ITEM FOR ENVIRONMENTAL BOARD AGENDA

PROJECT NAME: Block at 26th Street

SITE PLAN: SP-2011-0032C.SH

REQUEST: The applicant is requesting to remove a heritage tree with a stem greater than 30 inches as allowed under LDC 25-8-643

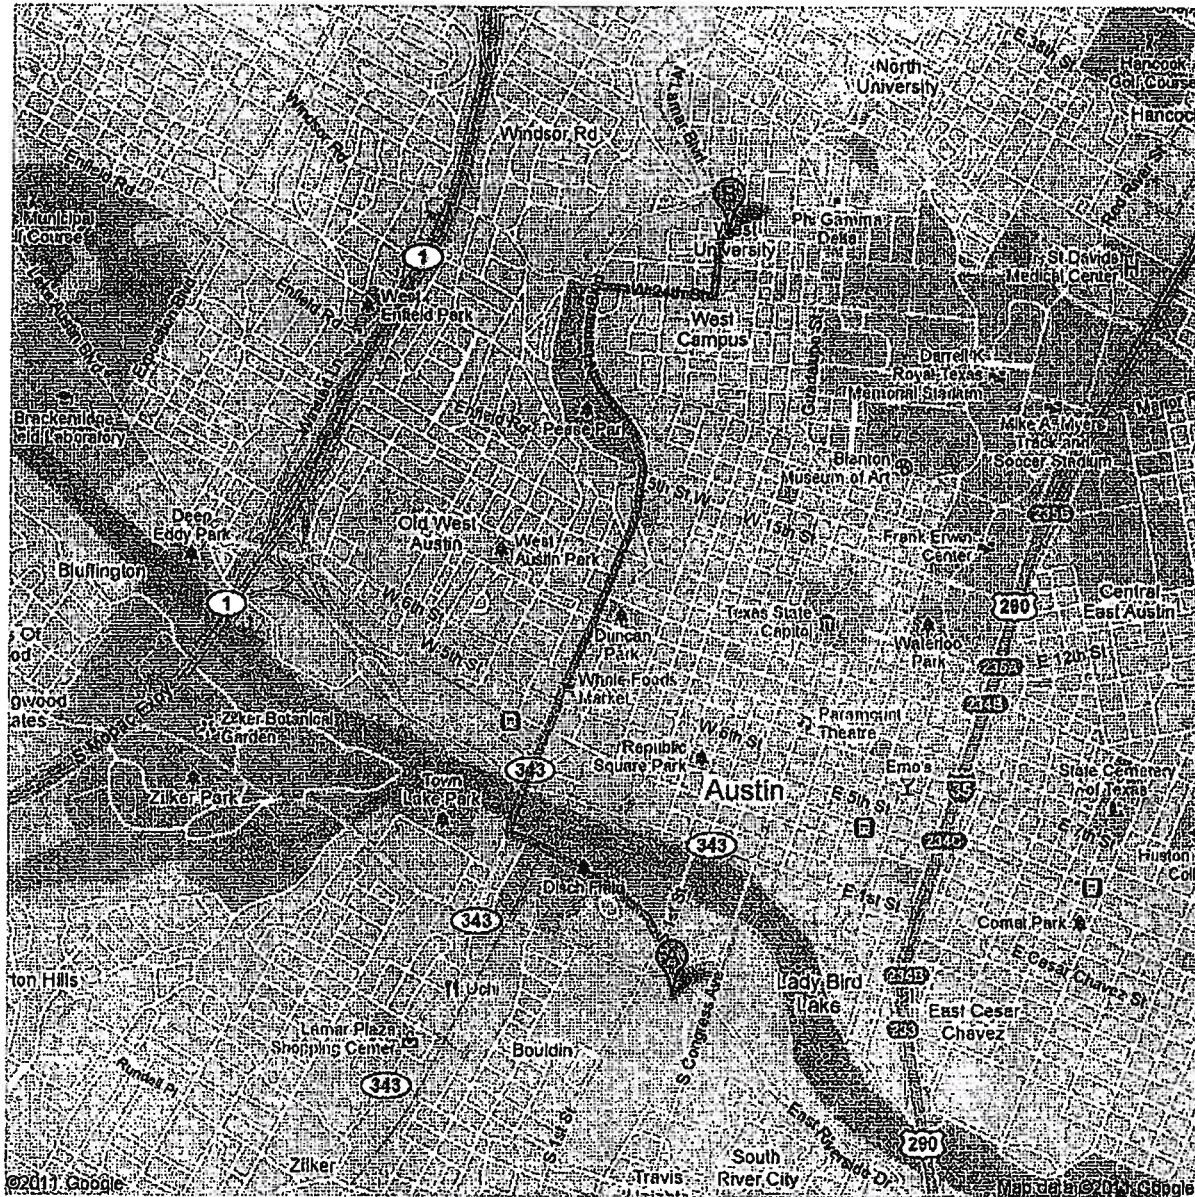
The following information is being provided in regards to tree no. 1893 on the attached site plan sheet for the Block at 26th Street project. Removal of the 30 inch pecan is being requested. We hereby ask that the variance request be placed on the June 1, 2011 Environmental Board agenda and the June 14, 2011 Planning Commission agenda.

1. The proposed driveway on West 26th Street aligns with Pearl Street, as shown on the attached site plan sheet 3. According to Section 5.3.1.K of the Transportation Criteria Manual, "[a]ll Type II and III driveways on undivided collector streets shall be designed to align with opposing streets or driveways or be offset by a minimum of 80 feet (measured from edge to edge)." Alignment of the driveway with Pearl Street is the optimal multi-modal configuration, since pedestrians, bicyclists, and vehicles would expect a four way approach and are used to handling that traffic situation. Offset driveways create an additional location for pedestrian, bicyclist, and vehicular conflict.

5. Overall, approximately 90 caliper inches of trees will be removed onsite. However, approximately 100 caliper inches of trees are proposed to be planted as part of the streetscape within the ROW, as shown on attached site plan sheets 3 and 7. Location of the newly planted trees within the streetscape will place more appropriate types of urban trees in the area.

Exhibit #3

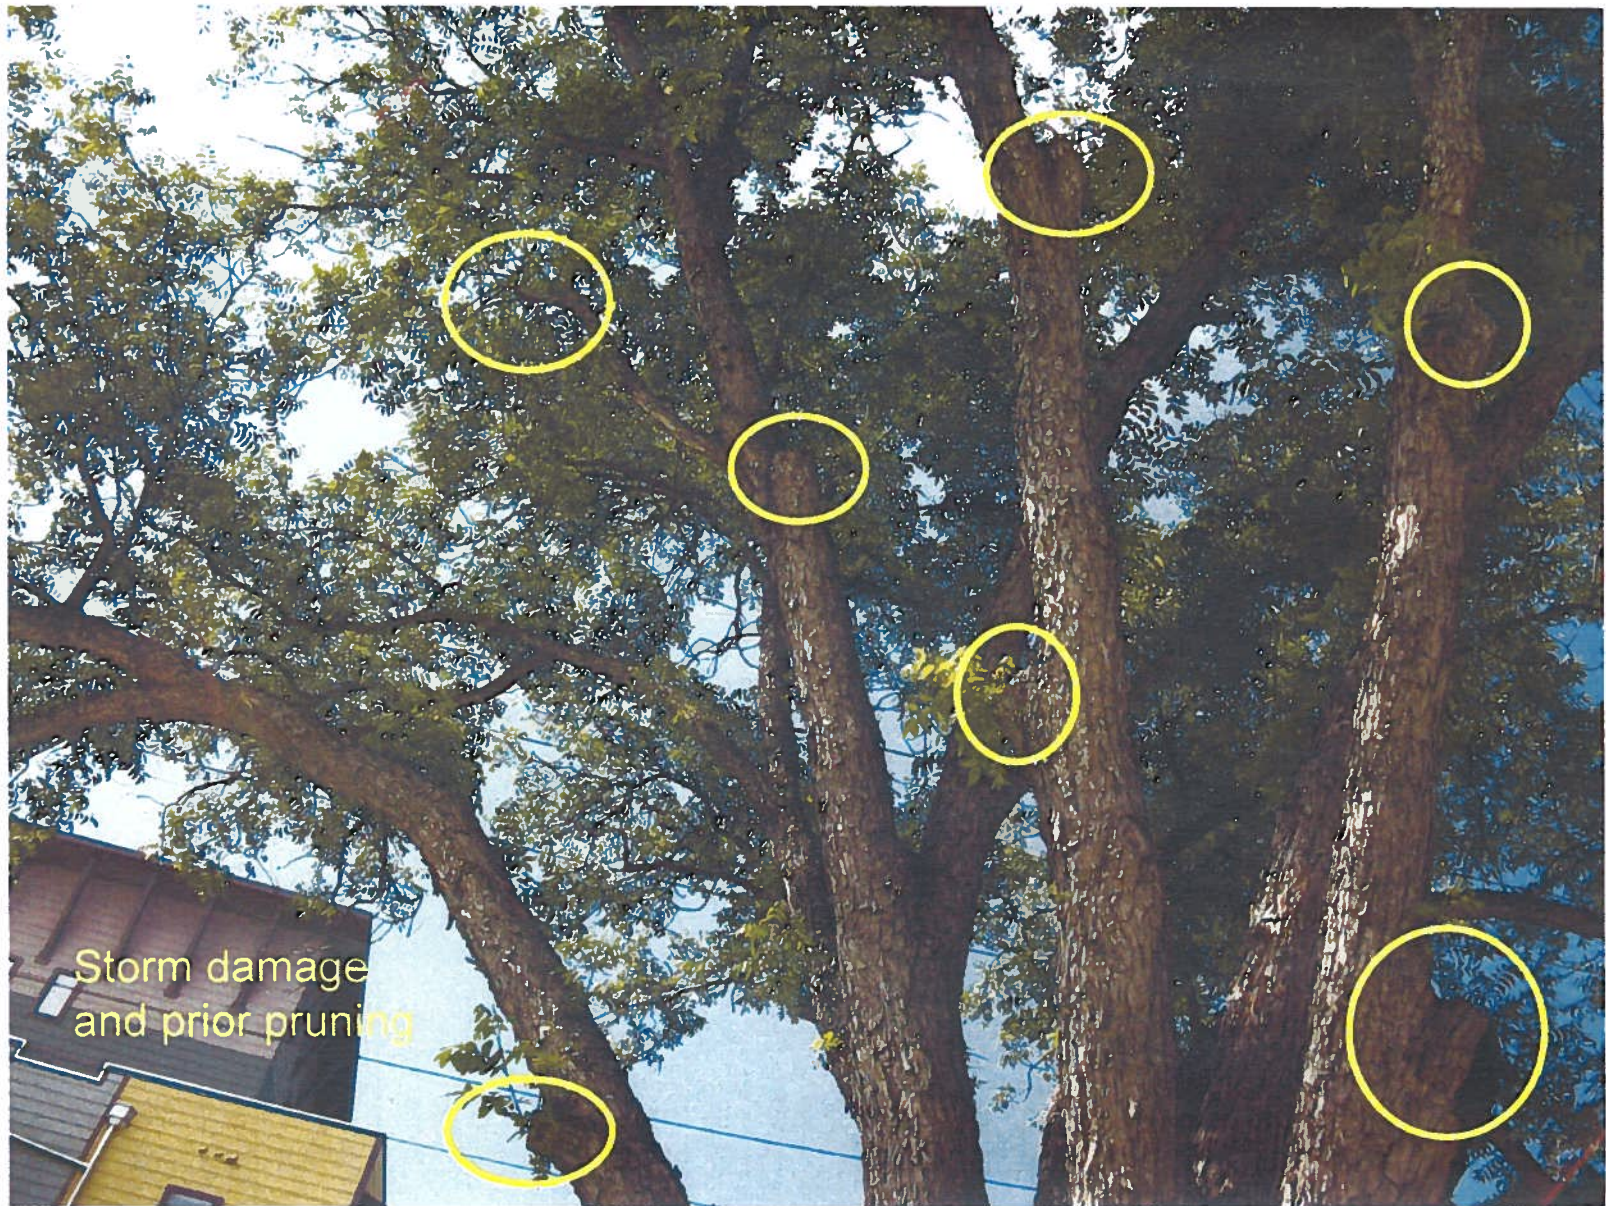
The subject tree is a 30.5 inch diameter at breast height (dbh) Pecan (*Carya illinoensis*). The tree height is 63 feet and the canopy spread is 55 feet (Exhibit 2). The trunk bifurcates into two co-dominate stems at eight feet above grade (Exhibit 3). Storm damage is evident by the presence of broken stems, though no noticeable decay or structural weaknesses are present (Exhibit 4). Minor pruning has occurred for utility clearing and likely from storm damage. There is minor deadwood and tip dieback in the crown though this is not uncommon in *Carya illinoensis* (Exhibit 5). This condition is likely exacerbated by poor soil and extensive compaction in the critical root zone (Exhibit 6). Given the aforementioned conditions, the subject tree is rated 'good' per the City Arborist tree evaluation (Exhibit 7).
